Subject: Transmittal—*Remedial Design/Remedial Action Work Plan for the North-South Diversion Ditch Detention Basin at the Paducah Gaseous Diffusion Plant, Paducah, Kentucky (DOE/OR/07-2008&D2)*

# Comment Response Summary

*Remedial Design/Remedial Action Work Plan for the North-South Diversion Ditch Detention Basin at the Paducah Gaseous Diffusion Plant, Paducah, Kentucky  
(DOE/OR/07-2008&D1 issued November 26, 2002)*

Figure 4. Project Organization

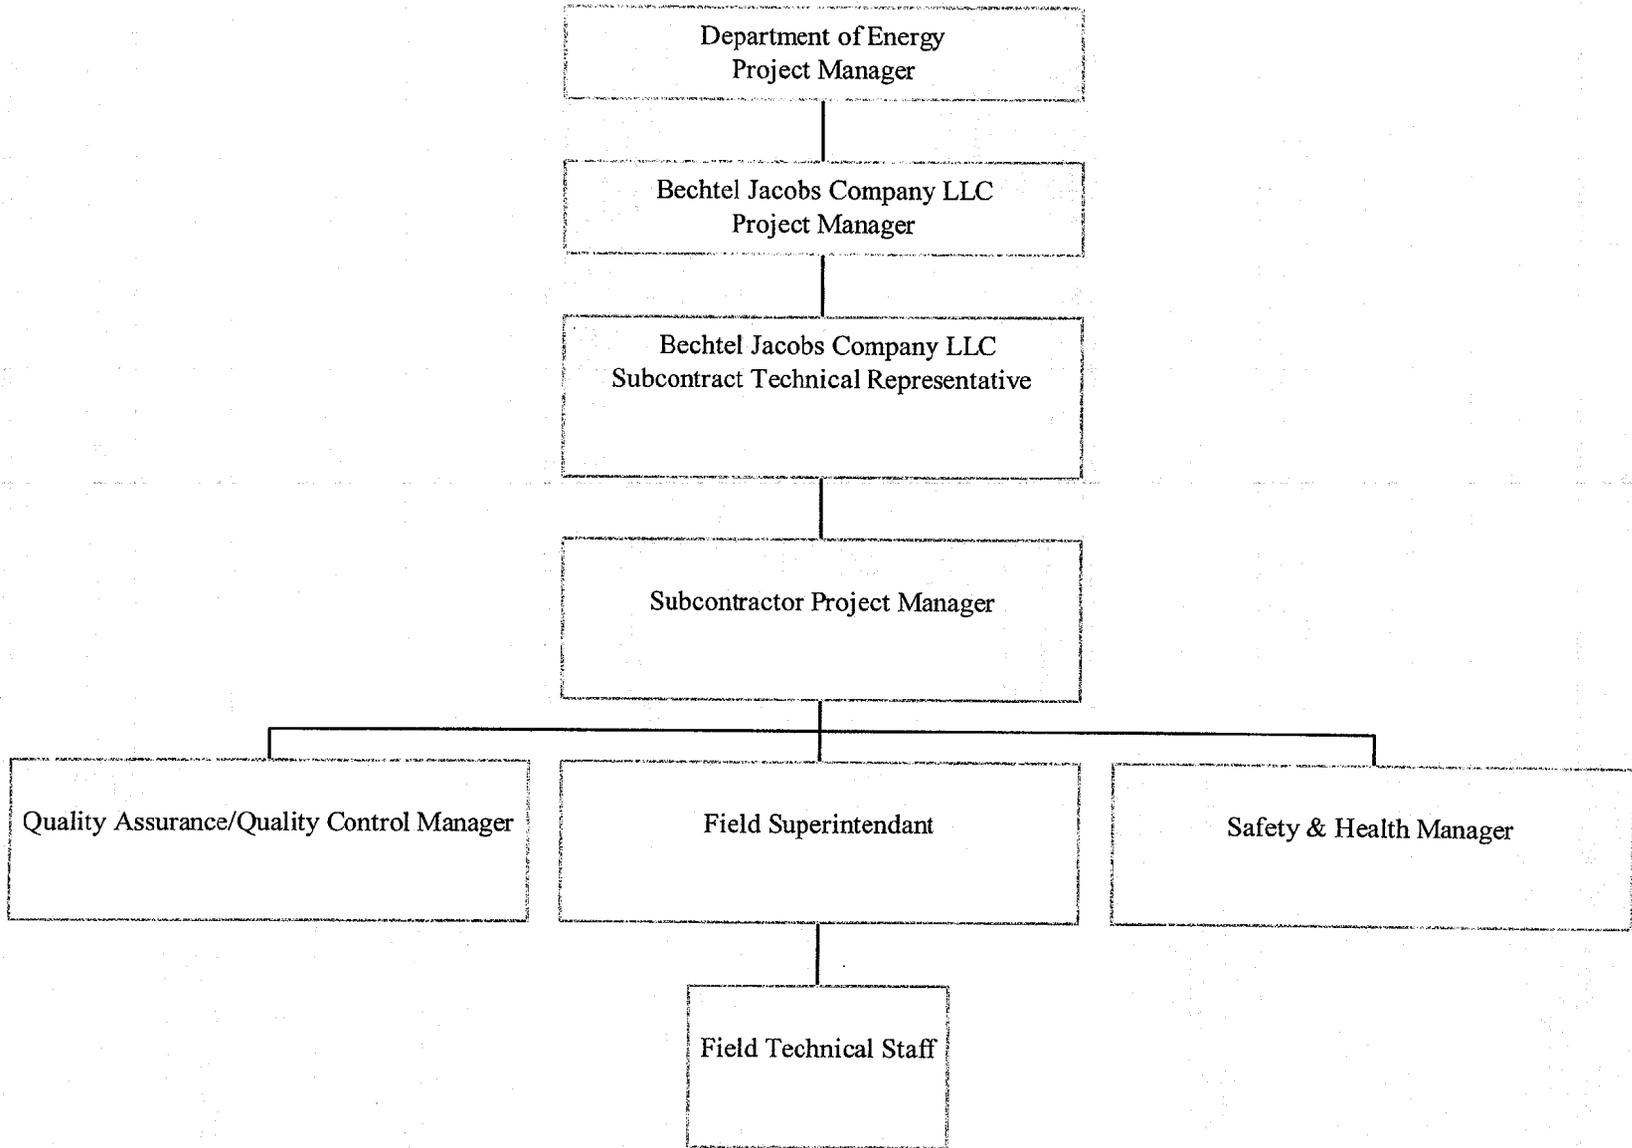
15.	Sect. 2; Page 7, Figure 4; Project Organization	KDWM: (1/24/03) S3  "The Safety and Health Manager identified in the figure should report directly to the Department of Energy Project Manager and not the Subcontractor Manager as noted in the figure."  	The Safety and Health Manager identified in the figure is the subcontractor's ES&H officer, who reports through the subcontractor's Project Manager to the BJC STR as shown.

Figure 5. Schedule

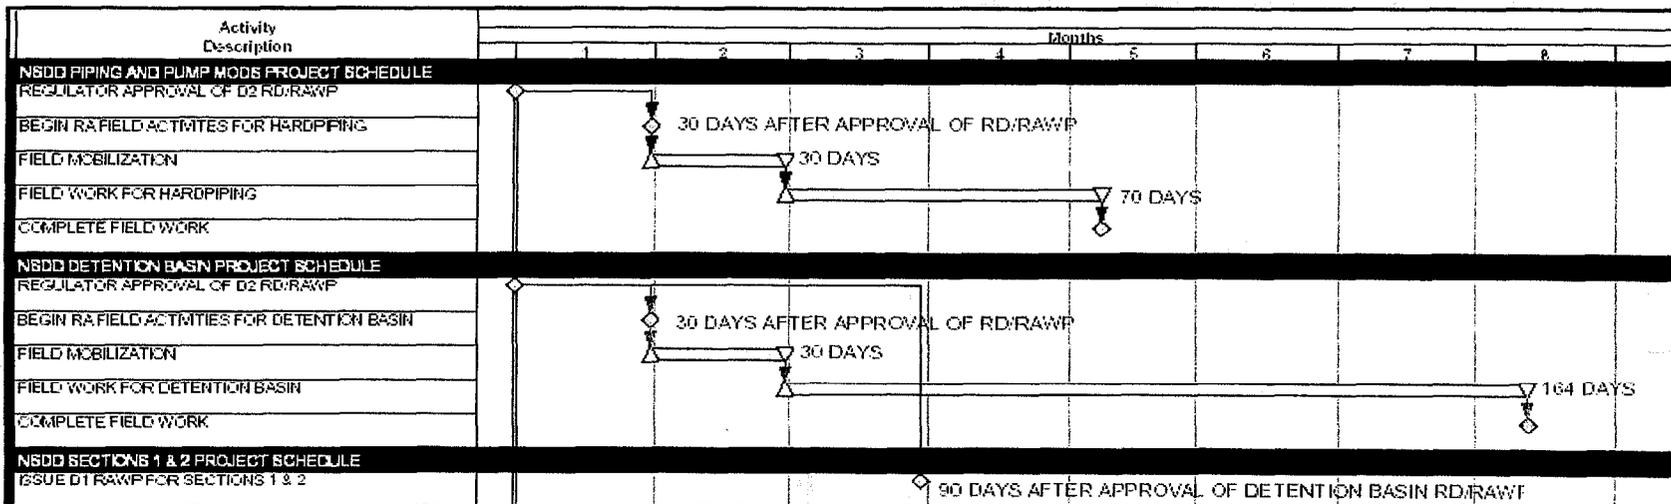
7.	Sect. 4; Page 13; Figure 5	EPA: (1/24/03) S6  "This figure is not completely legible due to poor reproduction, and the 'days' scale across the top of the schedule is not clear. Either provide a legible copy of the schedule as currently formatted, or re-format so all elements of the schedule are legible."	Agree. Figure will be modified as appropriate.

Comment Number	Sect. Page/Para.	Reviewer and Comment	Response
18.	Sect. 4; Page 13; Figure 5	KDWM: (1/24/03) S6  "The NSDD Detention Basin Project Schedule presented here is inadequate in that it fails to meet the requirements set forth in Section XV of the FFA. The FFA requires that the RAWP include a <b>'schedule for implementing the selected RA and for submitting a Construction Quality Control Plan, a Post Construction Report, an Operation and Maintenance Plan and a Final Remediation Report.'</b> While the basin project schedule presented in Figure 5 provides durations for field mobilization and remedial action completion, it lacks specific milestone dates for field mobilization start and remedial action field-start. In addition, the schedule neglects to include submittal dates for D1 revisions of the Construction Quality Control Plan, Post Construction Report, Operation and Maintenance Plan, and Final Remediation Report. DOE must provide all required milestones dates in its revised RAWP."	Agree. Applicable schedule milestone dates that are proposed or agreed to under the FFA will be included.
